**SUBJECT: Civil Action 80-73699 Consent Decree, BASF Wyandotte Corp. (BWC),
Riverview, Michigan Site Modification Program.**

SUBJECT: Civil Action 80-73699 - Consent Decree, BASF Wyandotte Corporation (BWC), Riverview, Michigan, Site Modification Program

Chronological Record of Events
Related to BASF Wyandotte Corp.
Riverview Site Seepage Problem.

SKETCH II-A

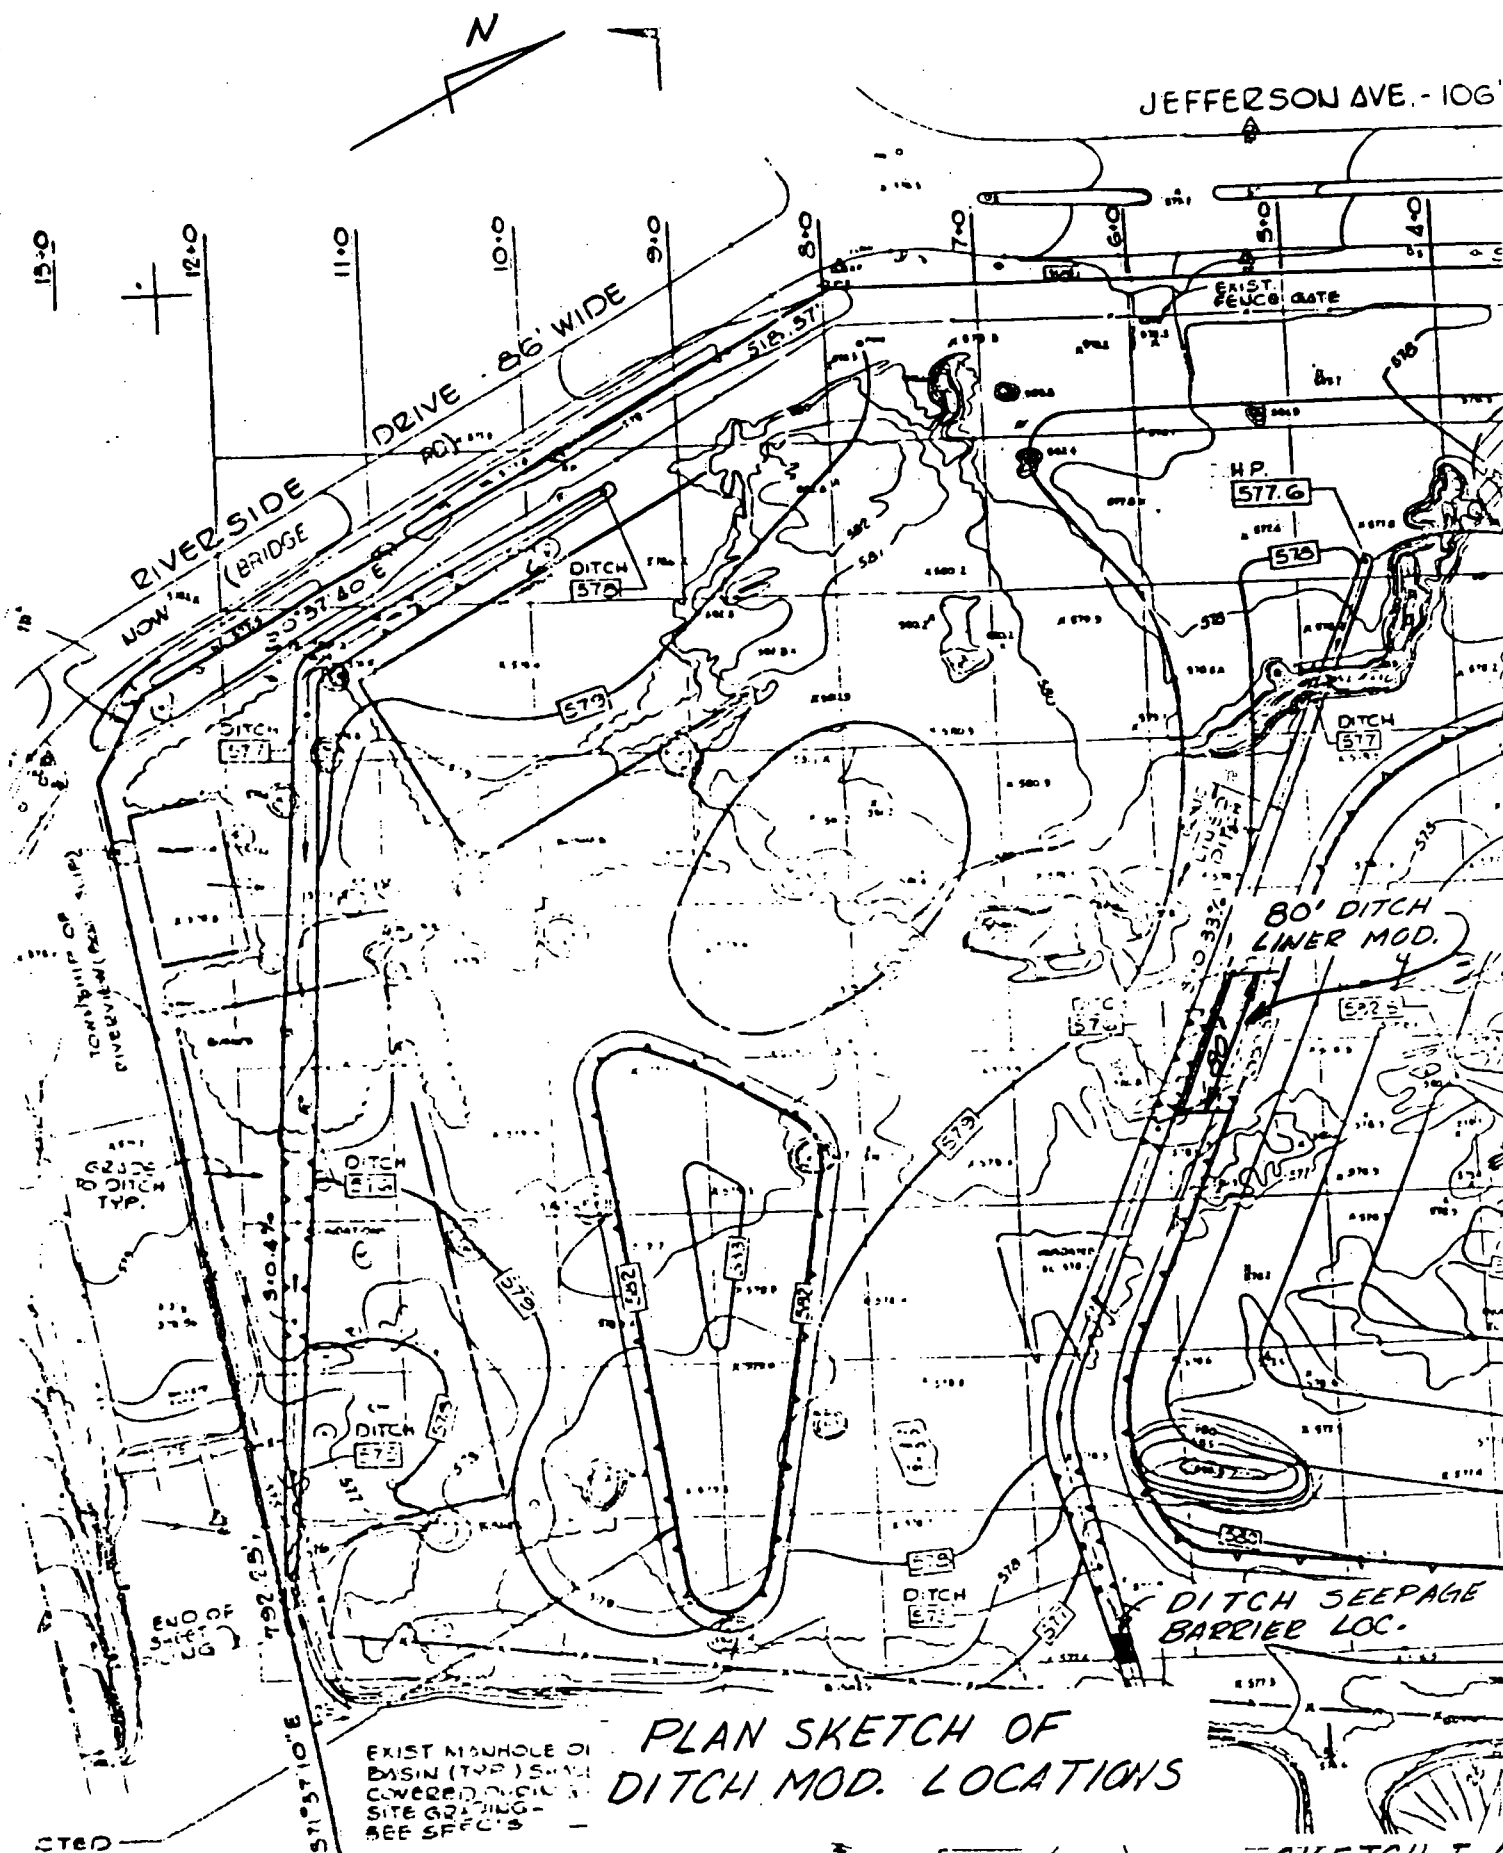
- c) At the discharge end of the ditch, to eliminate the erosion of the channel bottom caused by the ditch outfall during rain periods, BWC is going to extend the concrete surface 10 feet past the current shore line and replace the rip rap that was disturbed or lost during construction. An amendment to the MDNR, and Department of the Army permits will be required for this work. See the attached sketches II-A & B.

7. October 17, 1984 -- The amended Department of the Army Permit 84-07-06 was delivered to BWC. Refer to attached Sketches II -A & B. MDNR approval is also required and BWC is following up on it.

SKETCH I-B
10-30-84
CLW

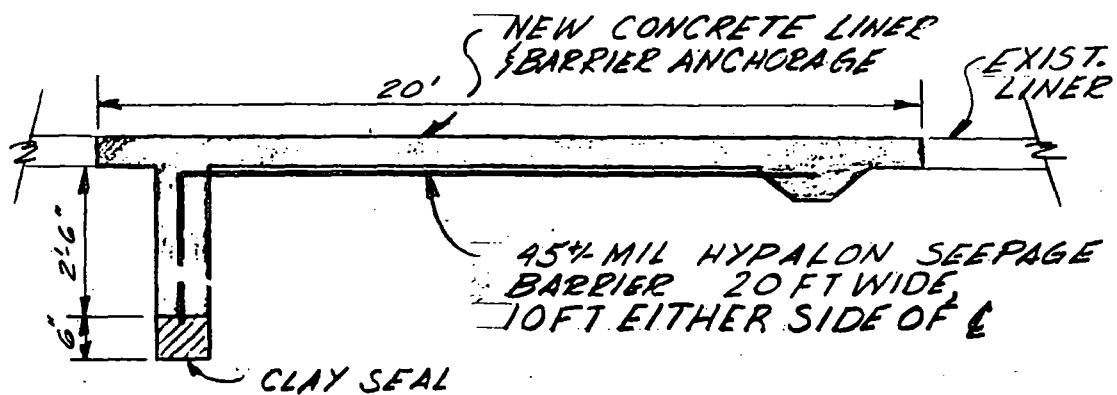
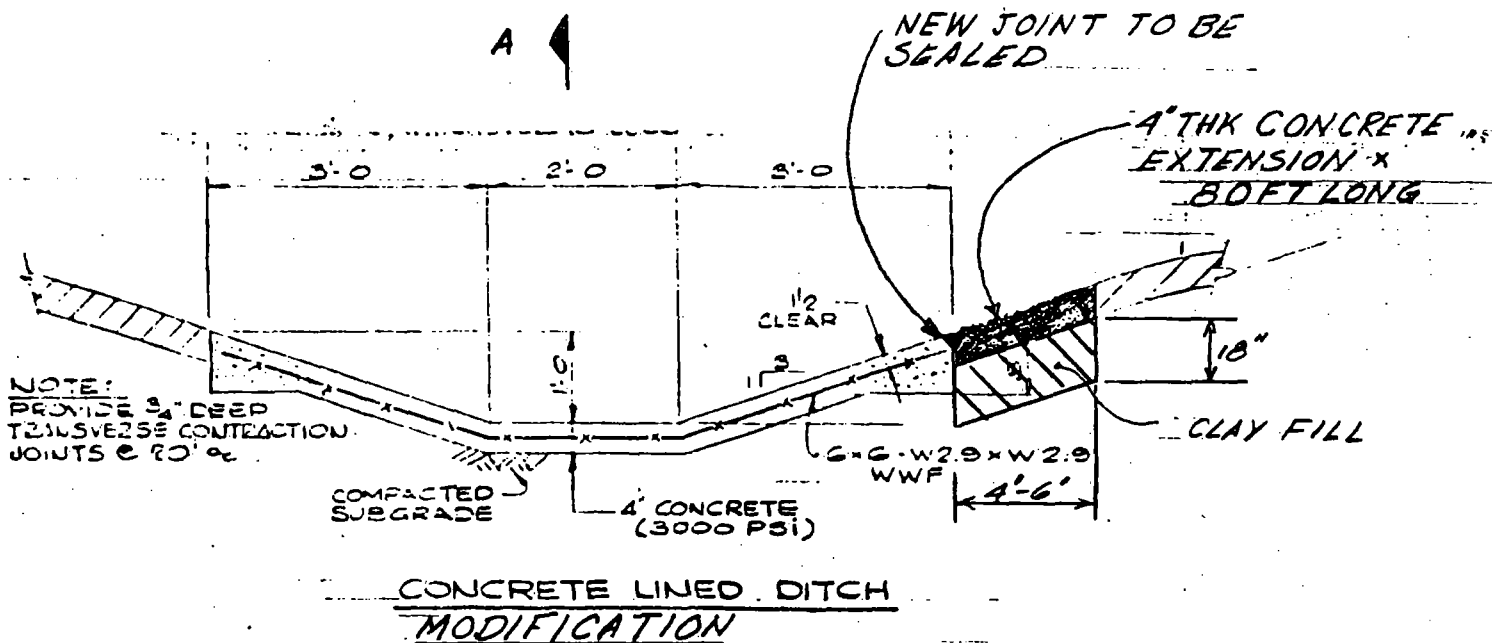
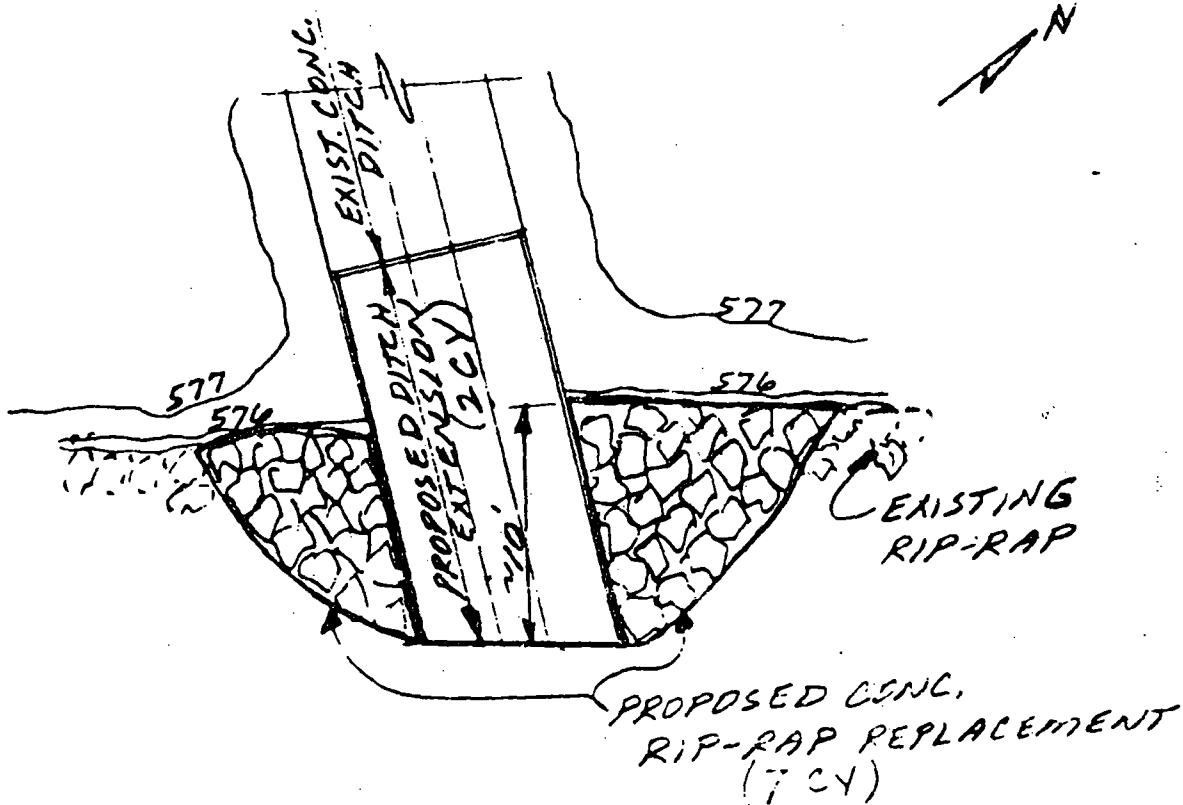
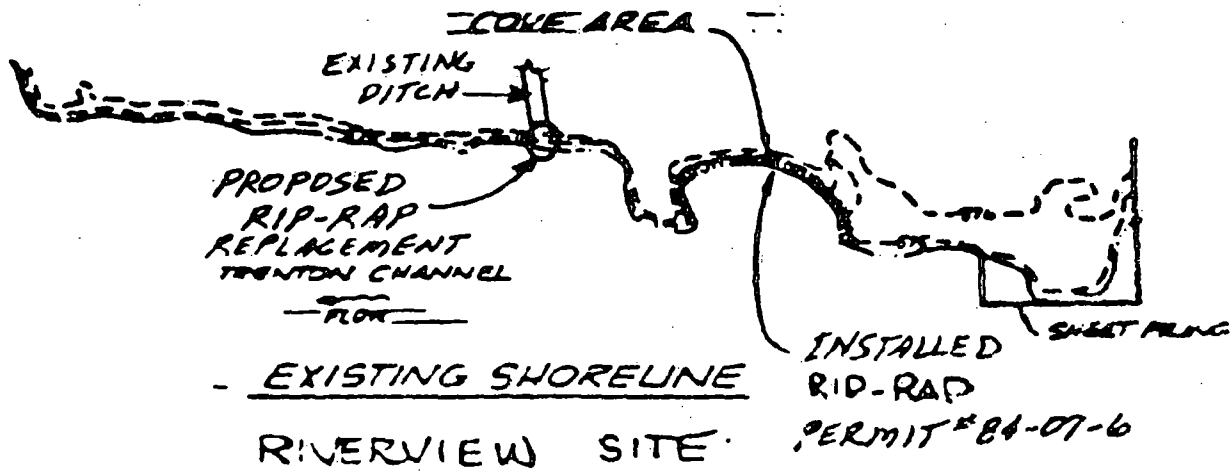
- a) In the area where seepage liquid is pooling along the north edge of the ditch an 80 ft. strip, approximately 40 ft. either side of Station 5, 2 feet deep and cut back along the new north slope to a point approximately 6 inches below level grade (about 4 to 6 feet wide) will be excavated and filled with 18 inches of clay. A visqueen barrier will be laid on top of the clay and 4 inches of concrete poured over the visqueen. Construction joints will be sealed to prevent leakage. See the attached sketches I-A & B.

- b) To prevent seepage from discharging into the Trenton Channel from the center ditch BWC is planning to rip out 20 ft. of the concrete ditch liner on the property, or west, side of the fence. A hypolon liner (45+/-mil) will be laid with the downstream end in a 3 ft. deep by 3" or 4" wide trench and the upstream end anchored to the bottom of the new concrete liner. The trench will be filled with 6 inches of clay topped with 2'-6" of concrete with the hypolon liner centered in the filler. The trench will extend across perpendicular to the ditch, 10 ft. either side of the ditch center line. See the attached sketches I-A & B.

10. October 24 thru 26 -- No work done on center ditch modifications due to wet conditions. Seepage at ditch continues.
11. October 30, 1984 -- BWC has placed the clay and poured the concrete liner extension in the 80 ft. section along the north side of the center ditch. A 20 ft. section of ditch liner near the east fence line has been removed. A 3" to 4" trench will be cut for the hypolon liner. New rip rap is being placed off the end of the ditch preparatory to constructing the 10 Ft. ditch extension. Refer to attached Sketches I-A & I-B.
